KD8 (-B) Modular Door Station(Main Modular)

Version: V2.2.63_build230204 Release Note

(2023-02-10)

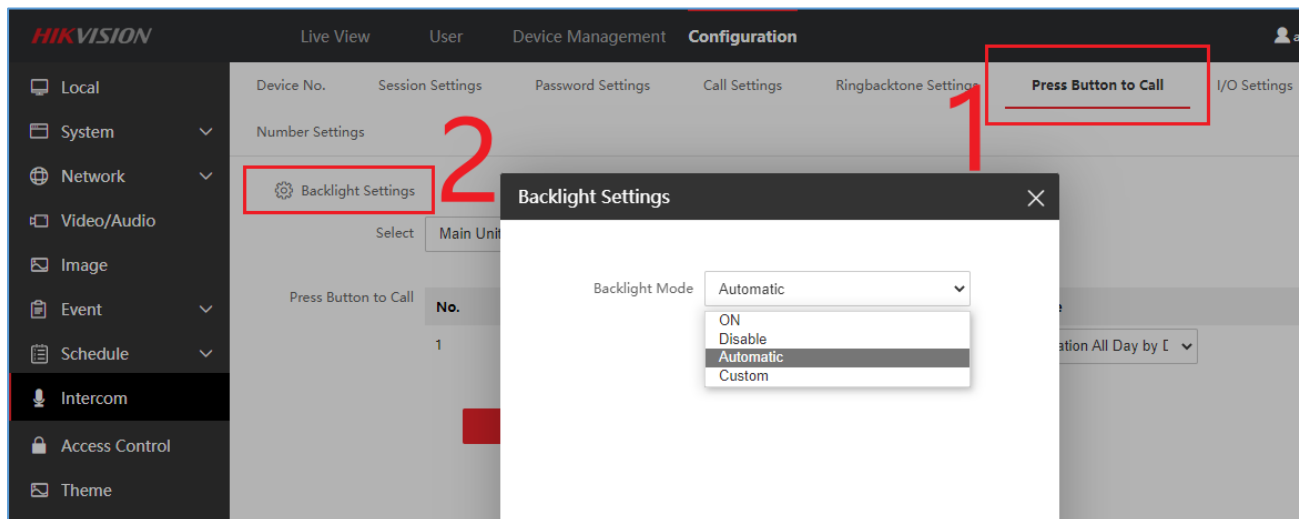
1. Add sub module **backlight** control: 4 modes (close, open, auto and custom), support DS-KD-KK, DS-KD-KP, DS-KD-INFO modules

Close: always OFF

Open: always ON

Auto: ON and OFF according to the ambient light brightness

Custom: ON and OFF according to configured time schedule

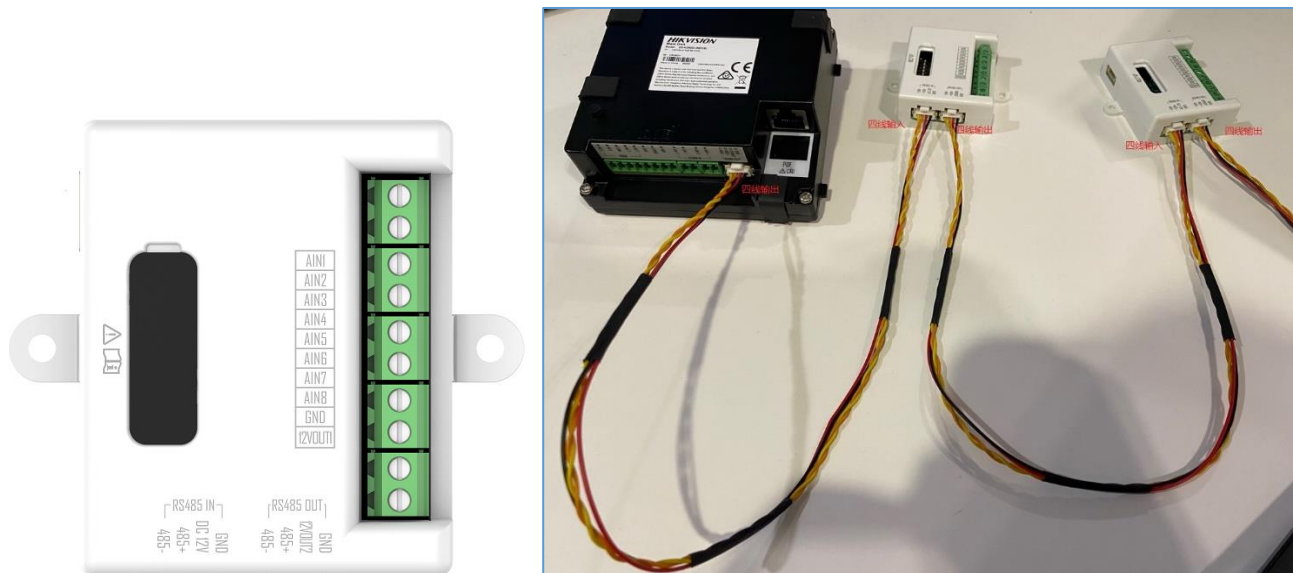
2. Compatible with new button extending sub module DS-KD-AL8, the module is configured and upgrade firmware from main module KD8003 remote configuration, you can link the alarm input No. to indoor station room No., once the input is triggered (short connected), the linked indoor station will be called.

- Maximum support 20 button extending modules cascading
- Each DS-KD-AL8 support 8 alarm input signal, so totally maximum 160 alarm inputs can be connected to one KD8003.
- Each module should have a unique DIP switch address.
- Make sure all modules are connected and each use unique DIP settings before power on the main module KD8003

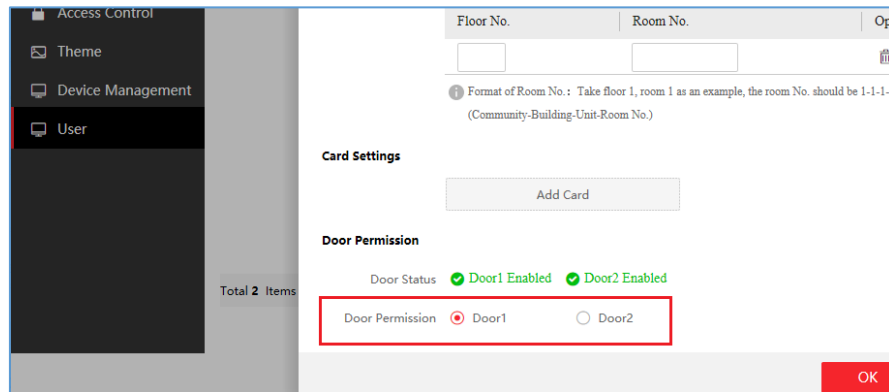
4. Support capture device image through ISAPI protocol.

/ISAPI/Streaming/channels/1/picture?snapshotImageType=JPEG&videoResolutionWidth=1280&videoResolutionHeight=720&imageQuality=better

snapshotImageType: picture format, only support JPEG now

videoResolutionWidth: videoResolutionHeight: picture resolution, if not use this parameter, by default it's 704*576. Supported resolution: 1280*720, 704*576, 704*480, 352*288, 352*240, 176*144, 176*120

imageQuality: support best, better, normal, general

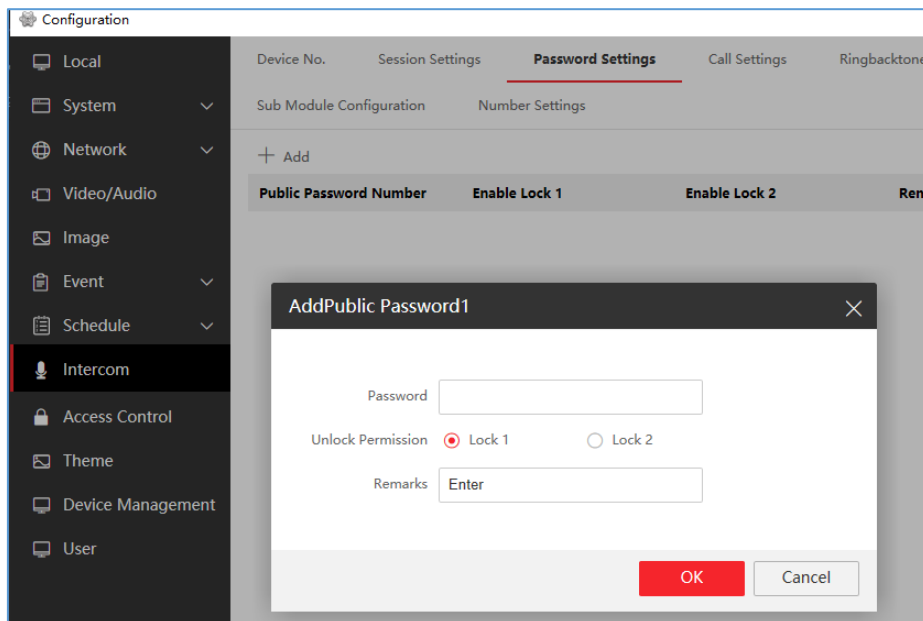
1. Support swipe card to open lock2: when adding new person, you can link to lock 1 or lock 2, and after swipe card, the related lock will be open.

Note: before the lock was linked to card module DIP switch, now we cancelled this logic so that we can open different lock with same card module.

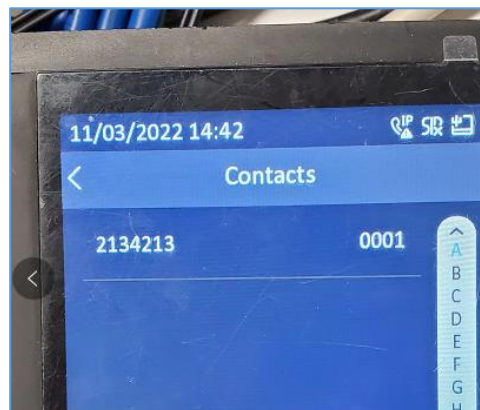
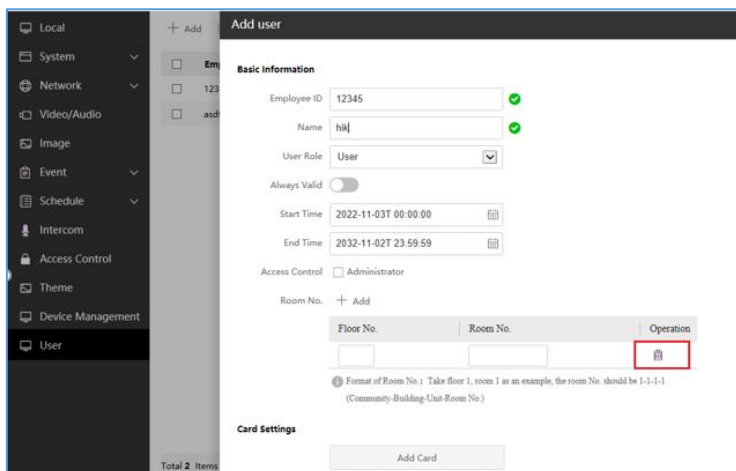
4. Support not showing the person in DS-KD-DIS and KD-TDM module.

When adding person, if you don't input the room No., this person will not be displayed in KD-DIS or KD-TD/TDE/TDM module

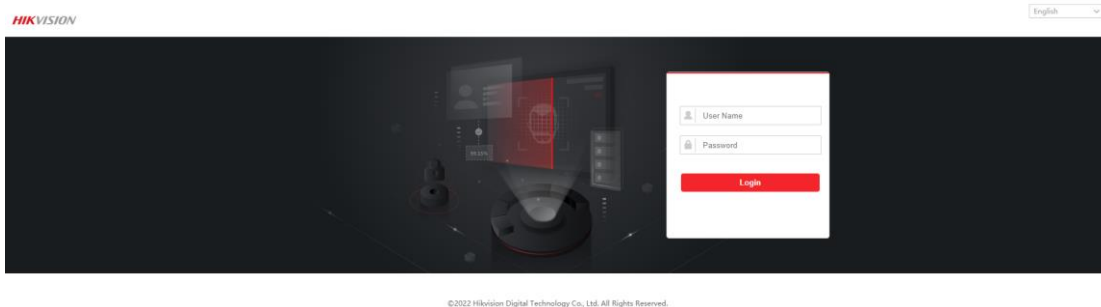
2.1 Support the Web Client to login:
